**RE: Enterprise Products Operating LLC
Response to GHG PSD Permit Application Information Request
Propane Dehydrogenation Unit: Mont Belvieu Complex
Mont Belvieu, Chambers County, Texas**

**Enterprise Mont Belvieu PDH Plant
GHG Permit Application
Responses to Questions in June 7, 2013 Completeness Letter
June 21, 2013**

Propane Dehydrogenation Unit
 Mont Belvieu, TX
 Process Flow Diagram
 Figure 4-1

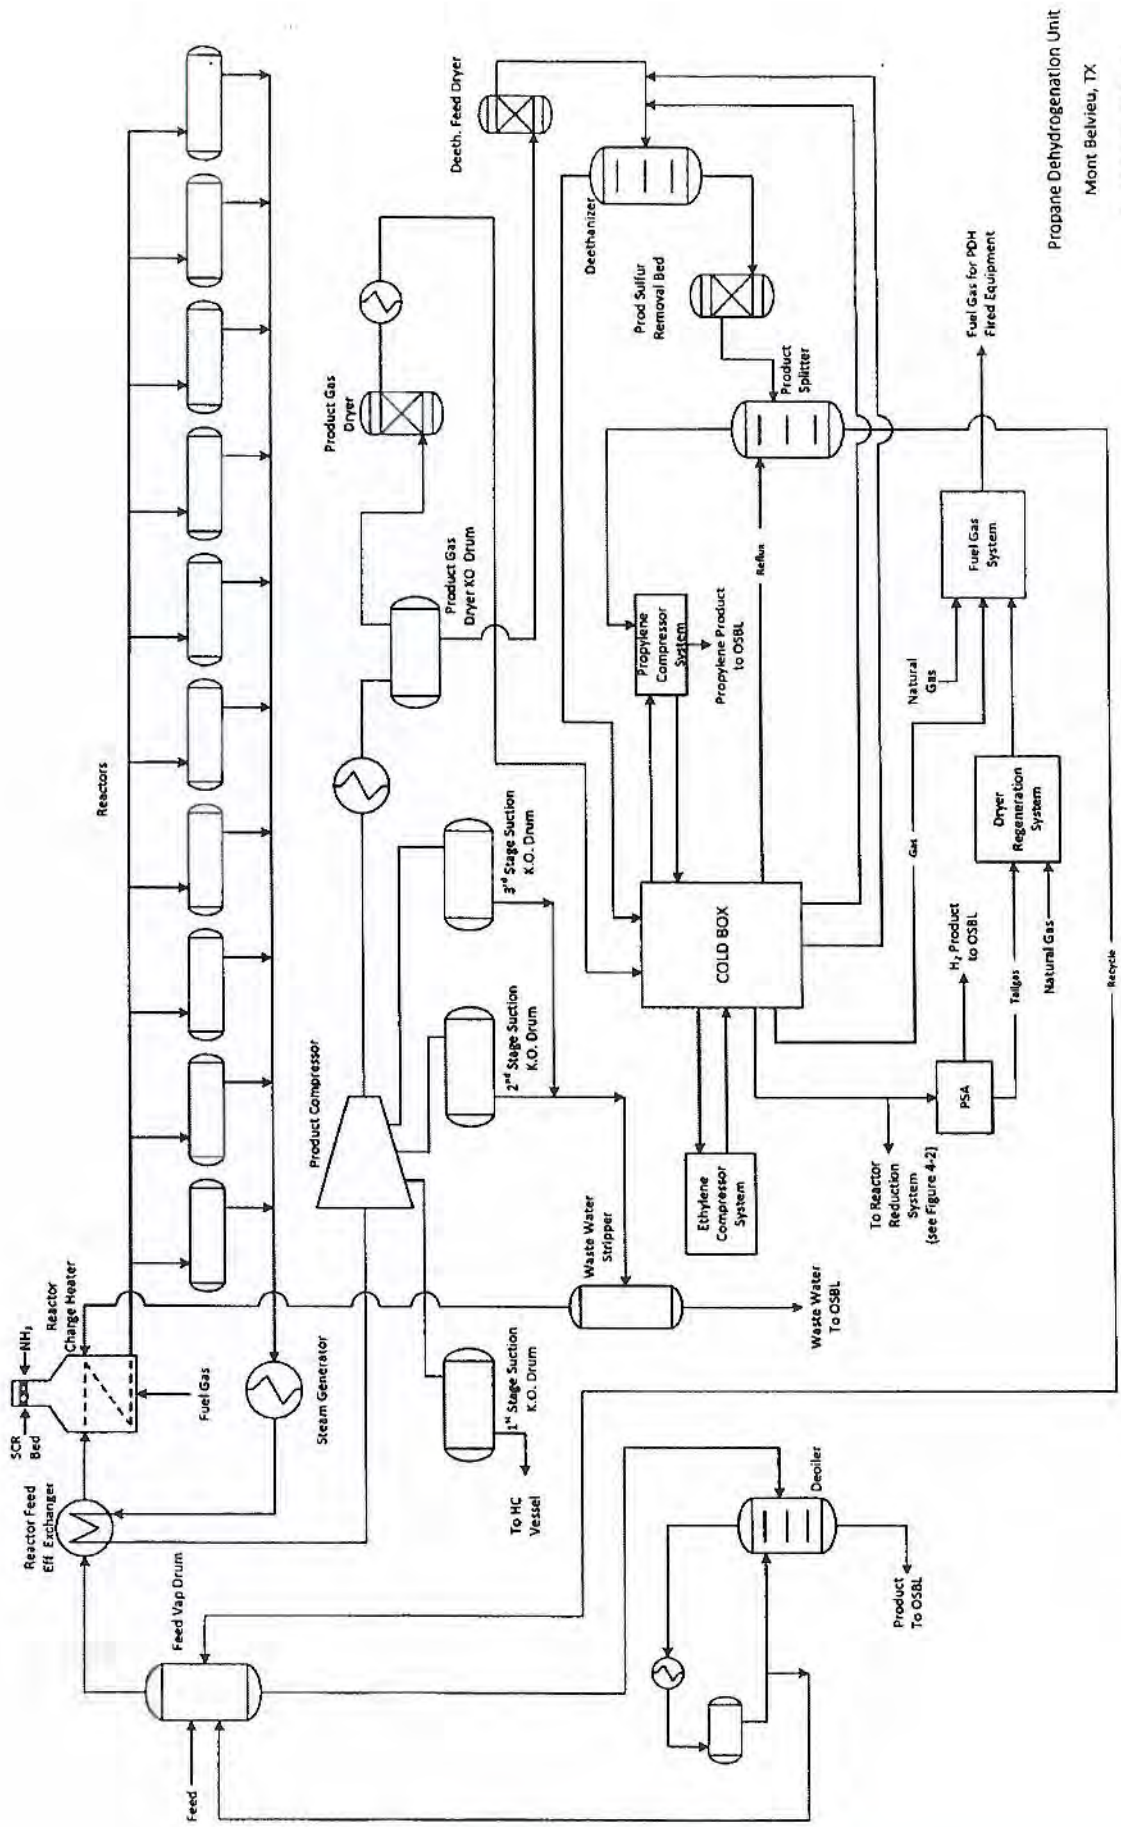
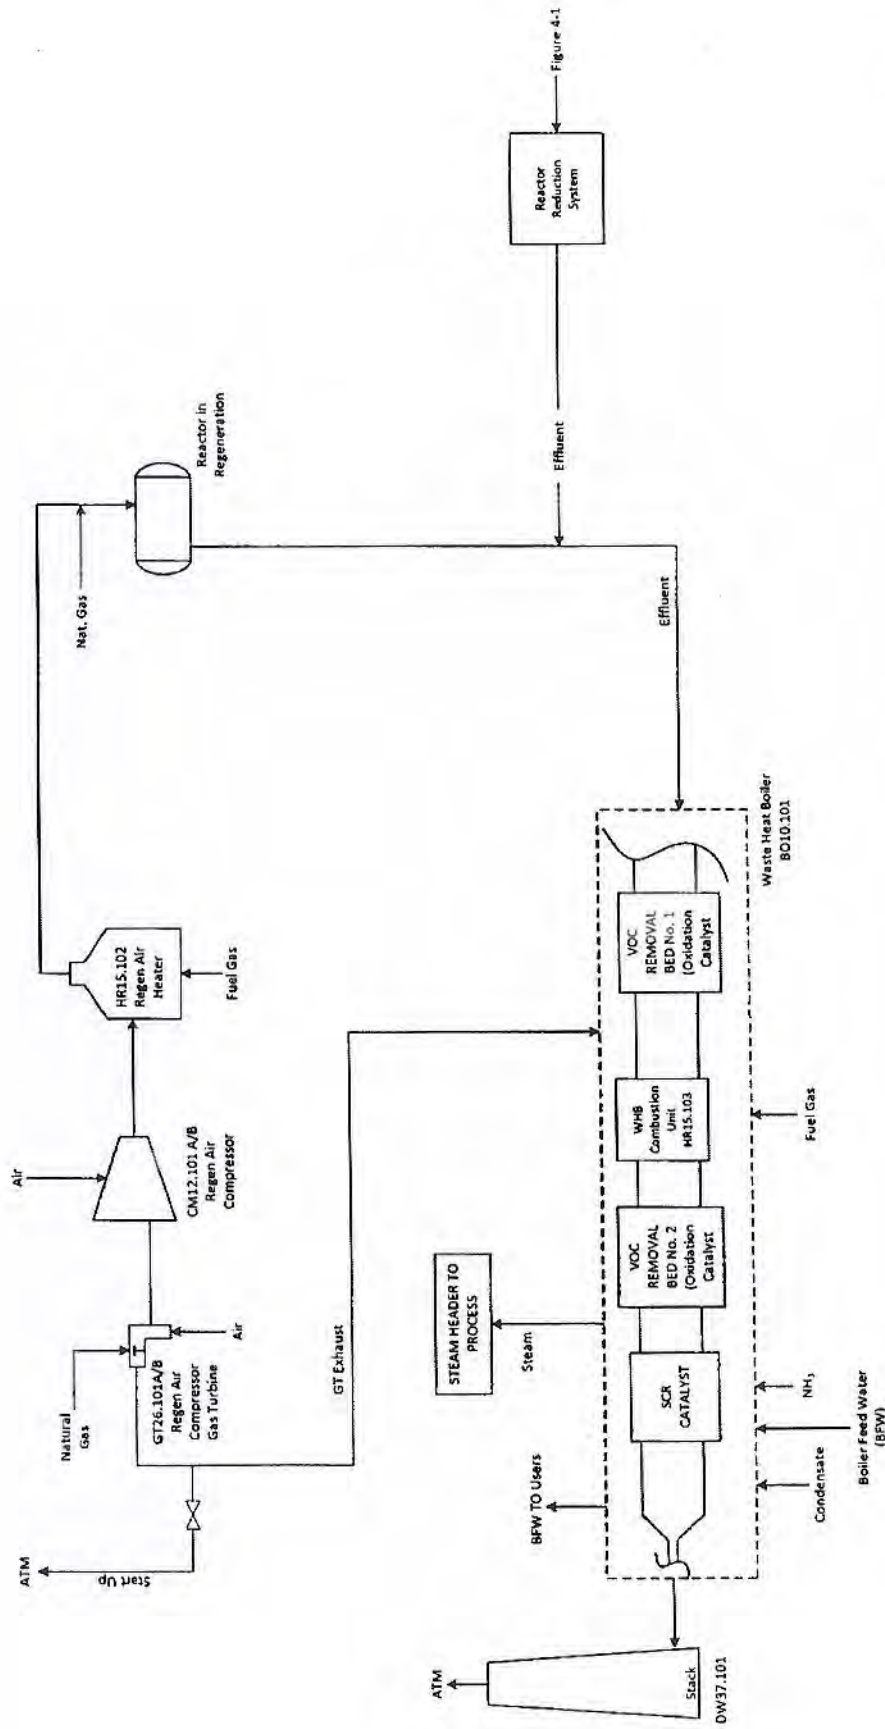
1. See the attached process description and flow diagrams that have been revised to more clearly describe the process. If additional questions remain, Enterprise is available to meet in your offices at your convenience to address questions.

2. See the attached process description and flow diagrams that have revised to more clearly describe the process. Specific responses to questions 2.C, and 2.I are provided below. If additional questions remain, Enterprise is available to meet in your offices at your convenience to address questions.

A brief overview of the process is included below, and a simplified process flow diagram of the PDH process is shown in Figures 4-1 and 4-2.
